October 10, 1984

Docket No. 50-423
B11332

Millstone Nuclear Power Station, Unit No. 3
Use of Alternative Damping Criteria

Figure 3.7B-71

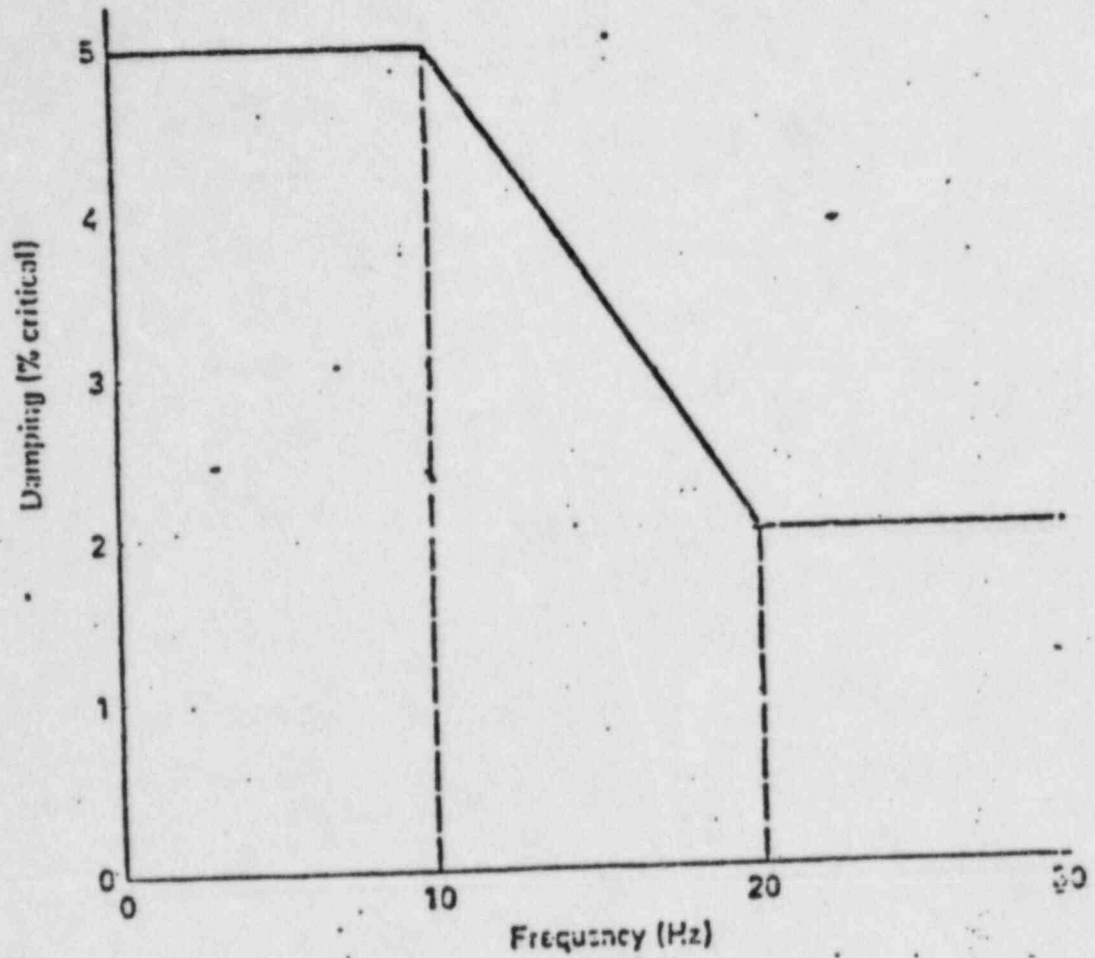
Obtained for discrete locations in the structure where the piping systems are supported. Enveloping and peak broadening procedures are applied on these ARS curves before input, as described below. Damping values used for piping are 0.5 percent for OBE and 1 percent for SSE (Section 3.7B.1.3), except that increased damping values may be applied on an as-needed basis for final stress reconciliation (or piping system backfits) in accordance with ASME Code Case N-411 (Figure 3.7B-71).

* For final reconciliation of pipe stress analysis or piping system backfits damping values as defined in ASME Code Case N-411 (Figure 3.7B-71) may be utilized for both OBE and SSE.
